Subject: Dairyland Power Cooperative – Alma Off-Site Disposal Facility Phase IV Landfill
Plan of Operation Modification for Initial Permitting of Coal Combustion Residuals (CCR)
Landfills – Addendum 1, Town of Belvidere, Buffalo County, Wisconsin
(License #4126)

On behalf of Dairyland Power Cooperative (DPC), this letter provides responses to the Wisconsin Department of Natural Resources (WDNR)'s April 26, 2023 Incompleteness Determination (Incompleteness Letter) for the Plan of Operation Approval Modification for Initial Permitting of CCR Landfills at the DPC Alma Off-Site Disposal Facility, Phase IV Landfill (Phase IV Landfill). This is Addendum 1 to the January 30, 2023 Plan of Operation Modification for the Phase IV Landfill (January 2023 Plan Mod).

This addendum is presented in the form of a letter such that each item requiring additional information is shown in bold text followed by DPC's response. If additional materials are needed to supplement the textual response, these supplemental materials are provided within attachments to this Addendum 1.

2
10 DIVERSION BERM
SCALE: 1"=5'

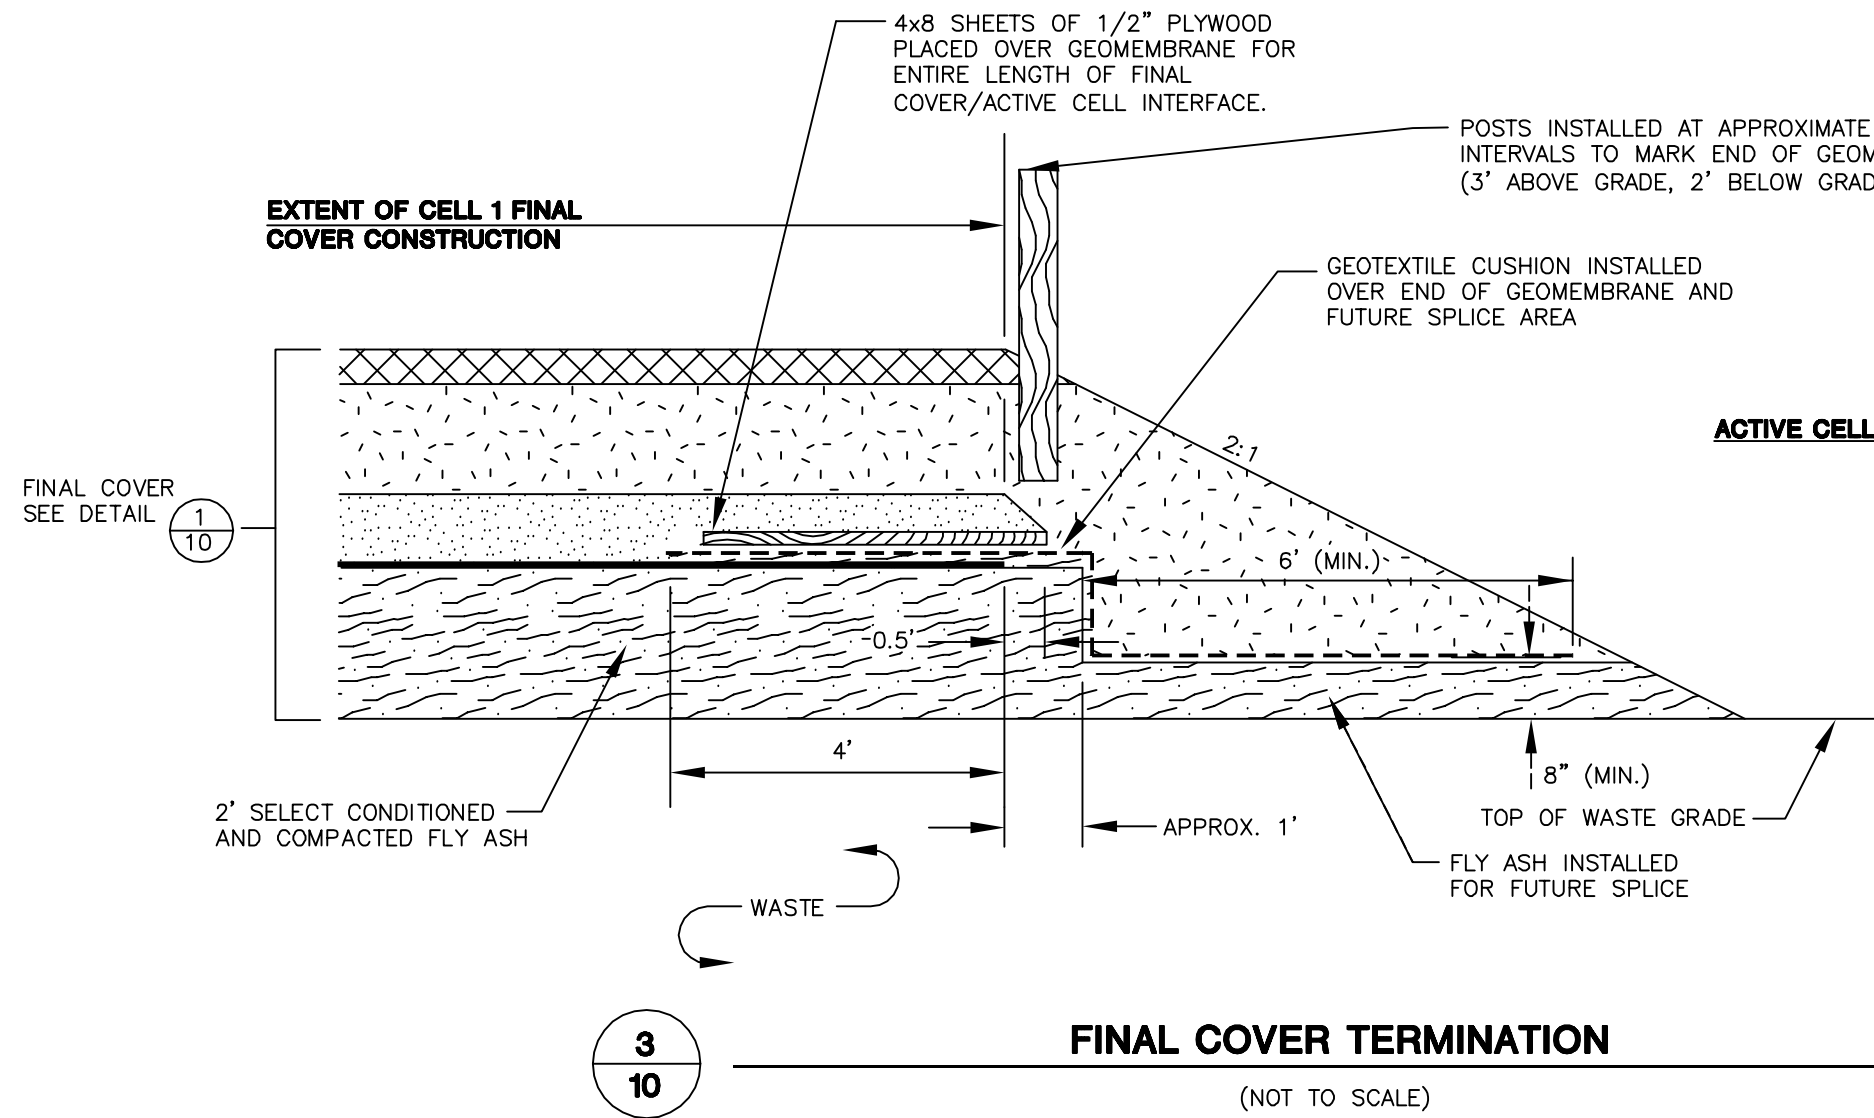
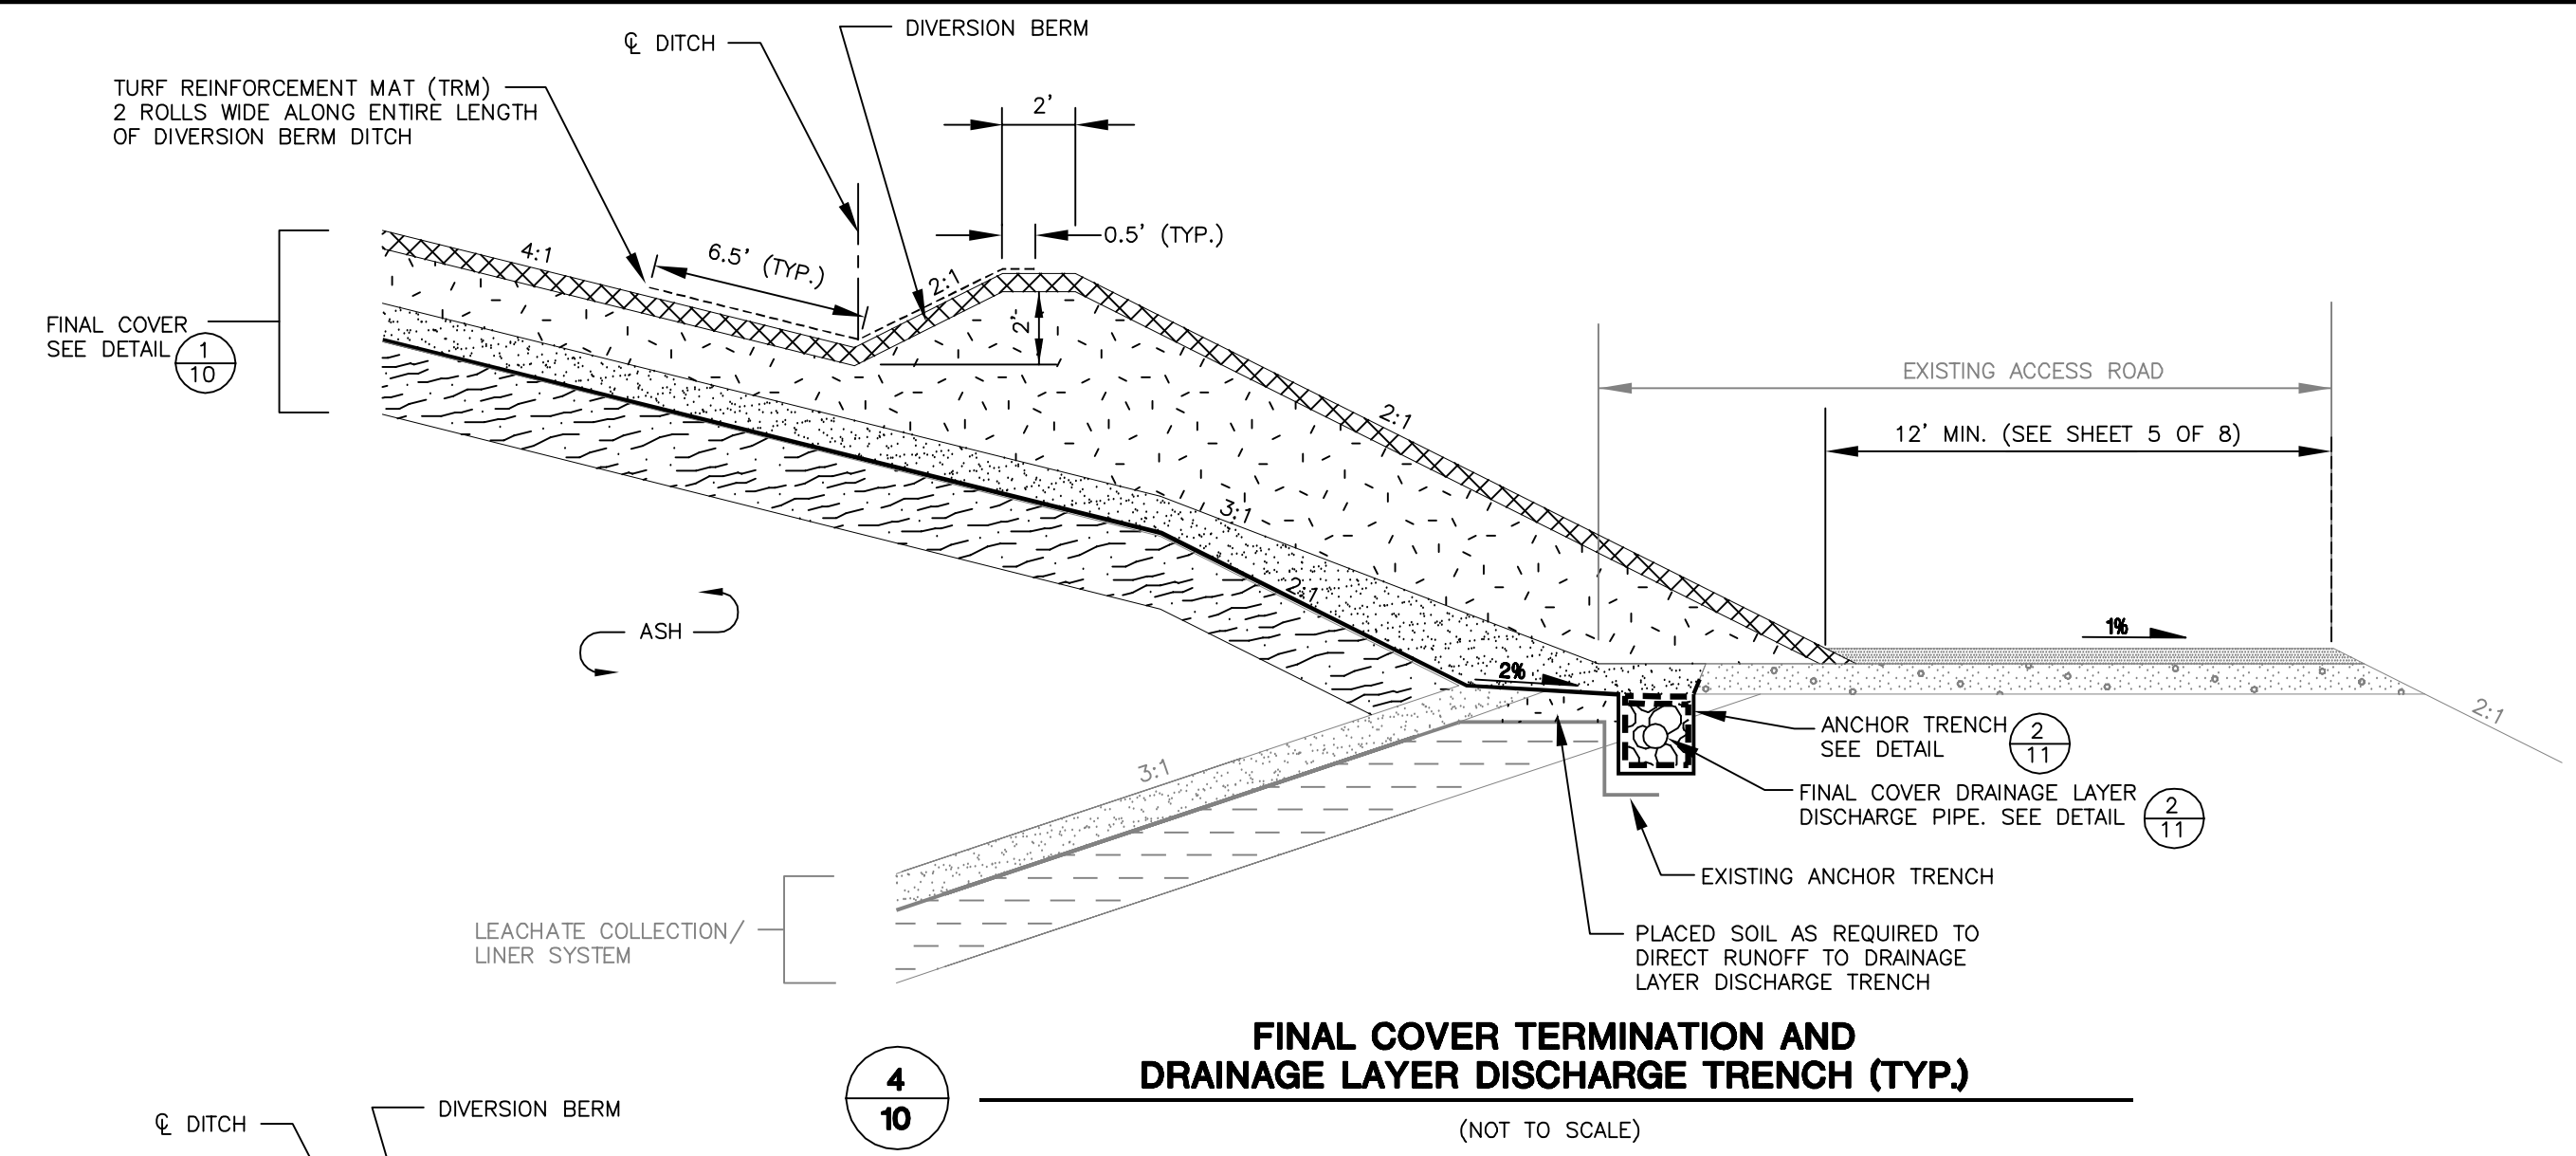
- b. Section NR 504.07(6)(b), (7), and (8), Wis. Adm. Code: Re-evaluate the final cover perimeter storm water drain system design and provide the specifications and application rates for fertilizer and mulch addition to topsoil.**

Stormwater Drain System – The existing and approved perimeter final cover drainage design includes a minimum 4-inch diameter drainpipe that is located along the diversion berms and toe of final cover slope near the perimeter berm of the proposed landfill as shown in Details 2 and 4 on Plan Sheet 19 in Appendix F.2. Coarse aggregate fill meeting the same gradation as the leachate collection drainage layer (minimum hydraulic conductivity of 1×10^{-2} cm/s) will be placed around the piping, which meets s. NR 504.07(6)(b). The October 2000 Plan of Operation Section 3.11.4 (Appendix F.2 of the January 2023 Plan Mod) proposed that the pipes located in trenches in the perimeter berm will follow the same slope as the top of berm and discharge through pipes located at 500-foot intervals around the landfill. Whereas pipes located in areas where the top of berm is flat will be sloped at 2 percent and discharge through pipes spaced at -200-foot intervals.
